Huawei Digital Power Technologies Co., Ltd.

Subject: Product Change Notice on Smart Power Sensor

Differences Between DDSU666-H And SmartPS-100A-S0:

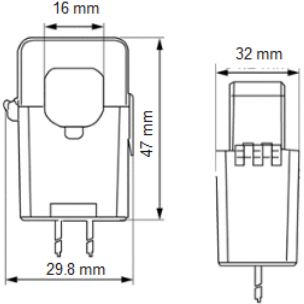
Before	After	
Model	DDSU666-H (Code 20022248)	SmartPS-100A-S0 (Code 20022248-002)	
		DDSU666-H (Chint)	YDS70-C16 (YADA)
Appearance

Label on Box (single product)			
Label on Box (multiple products)			
Dimension (W×H×D)	36 × 100 × 65.5 mm	36 × 100 × 65.5 mm	36 × 101 × 66 mm
Baud rate	4800/9600 (Default 9600bps)	4800/9600/19200/115200 (Default 9600bps)	
Data refresh period	≤0.35s	Power & Power Factor: ≤75ms Other data: ≤200ms	
Dimension of CT			
Pallet dimensions (L×W×H)	1200 × 800 × 1391 mm	1200 × 800 × 1134 mm	1200 × 800 × 1028 mm
Products/Pallet	144	288	288
